## **BCA (incl. ACCESS) ASSESSMENT REPORT**

**813 Wallgrove Road  
Eastern Creek**

**Prepared For:  
DHL Supply Chain**

Revision 2

Figure 1 – Perimeter Vehicular Access per BCA C2.4.

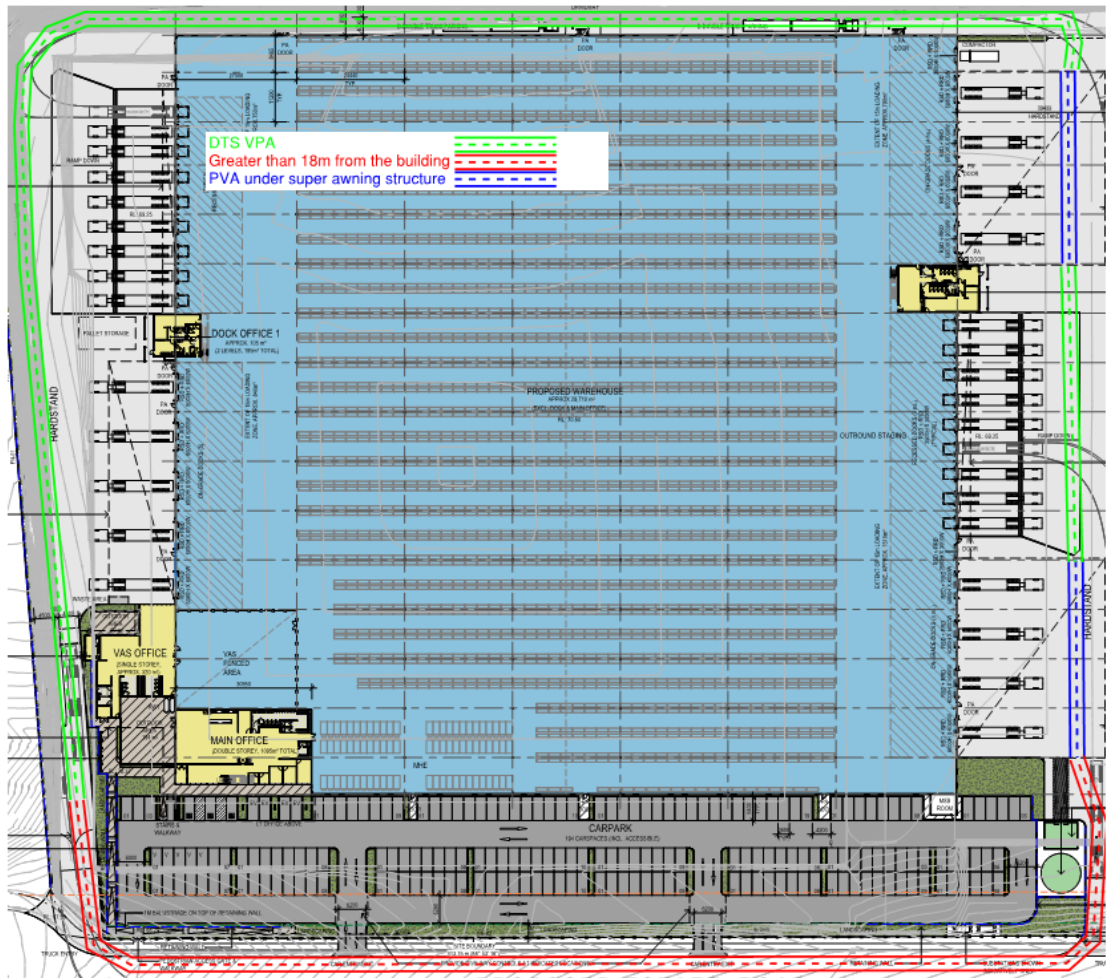
*Comments: The proposed Warehouse building does not comply with the provisions of C2.4 and thus the following non-compliance issue is required to be addressed as a Performance Solution by the Fire Engineer to demonstrate compliance with Performance Requirement CP9:*

- + *Perimeter Vehicular Access (PVA) is greater than 18m from the external walls along the southern side of the building off the proposed Estate Road – see Figure 1 over page.*
- + *PVA on the eastern side of the building is open, however it passes under the structural steel frame of the x2 super awning structures that are located over the loading areas on this side of the building, which is not strictly compliant with C2.4(b)(iv).*

Note 1: Any proposed sliding gates are to achieve no less than 6m unobstructed width or the reduced width will need to be included in the above Performance Solution.

Note 2: The driveways providing vehicular perimeter access must be designed with adequate loading capacities to withstand a fire truck and the gradients of any ramps and swept paths should take into consideration the requirements of the FRNSW Fire Safety Guideline – Access for Fire Brigade Vehicles and Firefighters.
